DEVELOPMENT REVIEW BOARD REPORT

CASE NUMBER/ **49-DR-2005**

PROJECT NAME Raintree Mini-Storage

REQUEST Request approval of a site plan & elevations for construction of a new

ATTACHMENT #6

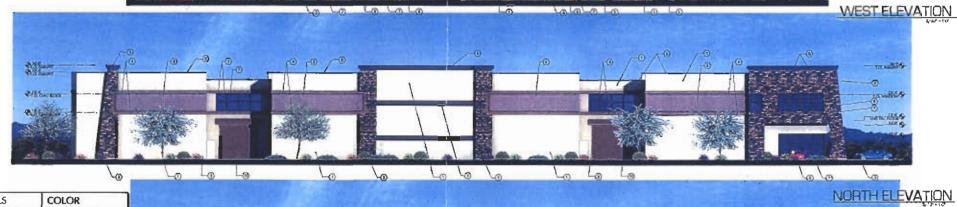
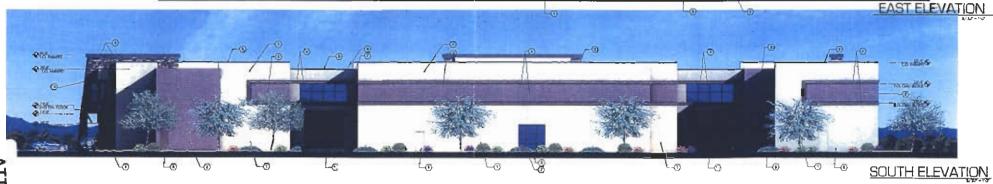
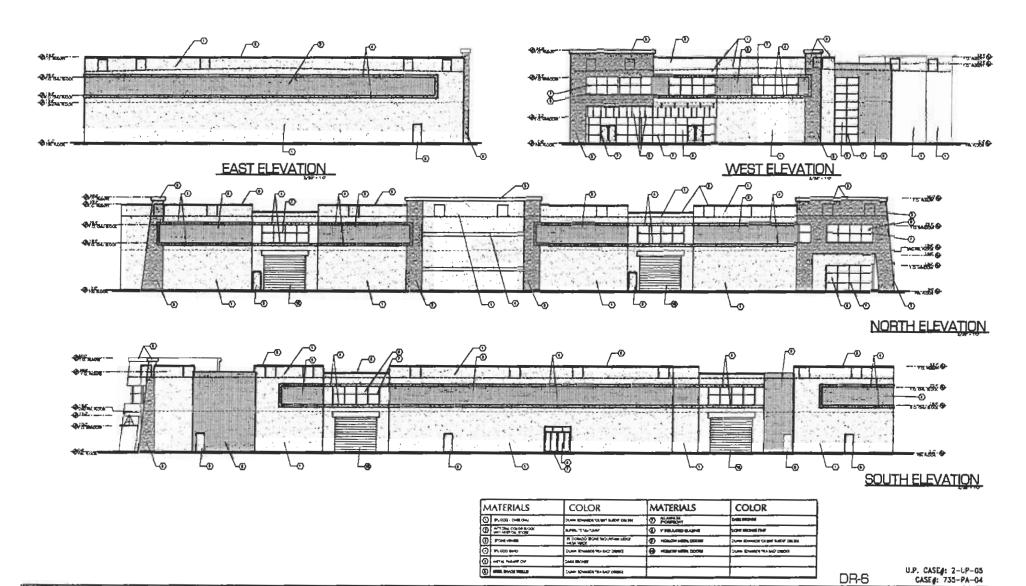
This case was continued at the August 25, 2005 DRB meeting to allow the applicant time to modify the building elevations. The Board indicated that the original proposal had an excessive variety of architectural elements and details and requested the applicant try to simplify the elevations. The applicant has subsequently modified the buildings architecture by removing a portion of the shade canopy that did not cover windows along the western exposure, providing additional support for 2nd floor stone veneer areas and simplifying the building's battered columns and parapet roof configuration along the northern elevation.
